DELEGATED OFFICER REPORT

WOKINGHAM
BOROUGH COUNCIL

Application Number:	252001
Site Address:	9 Hart Dyke Close, Wokingham, RG41 2HQ
Expiry Date:	4 November 2025
Site Visit Date:	27 October 2025
Proposal: Householder application for the proposed erection of single-storey rear extension with 2 no. roof lanterns and pergola following demolition of existing conservatory. Loft conversion creating additional accommodation with 1 no. dormers and 1 no. rear Juliet balcony. Single-storey extension to garage including loft conversion creating habitable accommodation with 1 no. dormer.

Figure 1. Preliminary Roost Assessment Survey Findings

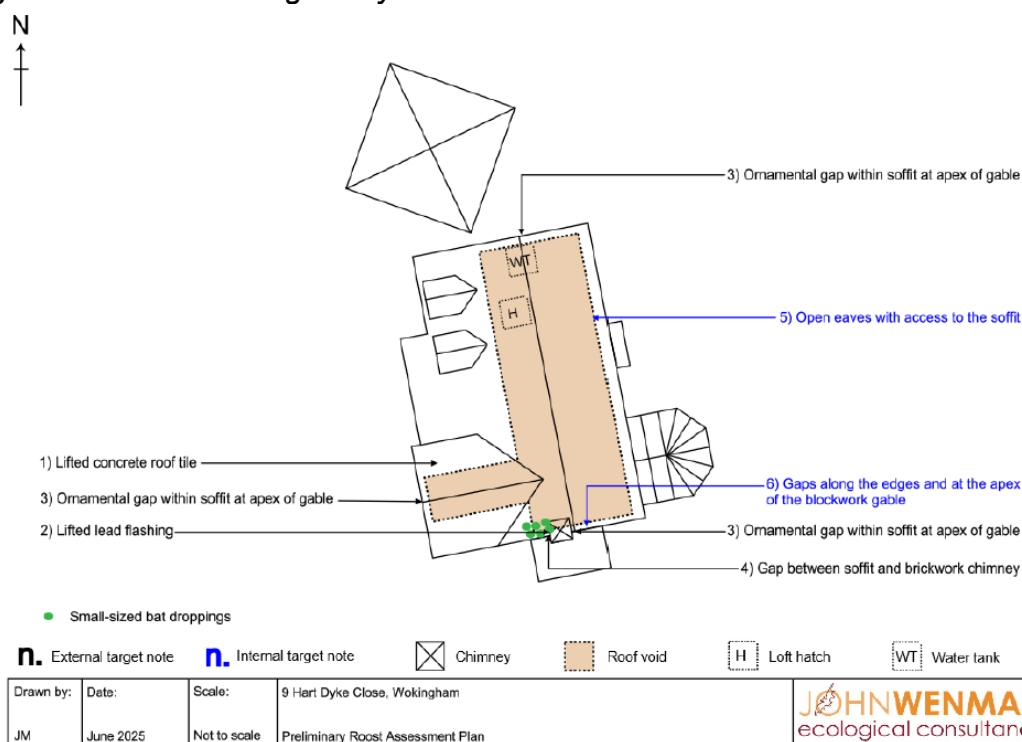
The PRA external inspection recorded slight lifting of the lead flashing and gap at the base of the southern chimney gap between the soffit and wall and against the southern brickwork chimney and ornamental gaps at the apex of each gable. In the internal inspection of southern blockwork gable with six small-sized droppings were observed at its base.

While the roof void is of a suitable size and condition for void dwelling bats and the lifted lead flashing and gap between soffit and chimney at the southern gable directly lead inside no evidence of bat species such as brown long eared bat were found. The

lifted tile to the front gable and other potential roosting features are suitable for crevice-dwelling bats such as pipistrelle. Evidence of crevice-roosting species is regularly hidden from view in areas such as gaps between tiles and internal linings/insulation including cavity wall.

Ecologist concluded that the loft conversion and extension to the house will not impact the confirmed roost at the southern gable end or any of other the potential roosting features they identified. They state that the existing soffits and gap under lead flashing at the southern end will be retained unaffected and the loft conversion will not change the availability of the southern gable wall, which will remain separate and insulated away from the converted living space, for roosting bats. There is a residual risk of indirect impact, and of a change in the status of the roost before he work begins, therefore, a precautionary approach to specific aspects of the work under a non-licensed method statement should be adhered to in order to avoid indirect temporary disturbance of the low suitability features to be retained across the southern elevation of the building as detailed in the Non-Licensed Method Statement Section 6.4, and to confirm there has been no change in the roost status. Provided that the proposed void conversion does not impact bat or the roost in the gable end I support the conclusion therefore it is unlikely that there would be any direct loss or if the precautionary mitigation measure proposed are secured by planning condition, there is no ecological objection to the development as proposed.

Condition: Unless otherwise agreed in writing by the council, all works are to be carried out in strict and accordance with the recommendations and proposed Non-Licensed Method Statement given in Section 6.3 and 6.4 of the submitted Preliminary Roost Assessment (John Wenman Ecological Consultancy, Ref R2974_PRA_a, June 2005). A suitably experienced ecologist must undertake a site walkover/check not more than three months prior to commencement of development to confirm that conditions have not changed since the most recent survey. Within one month of
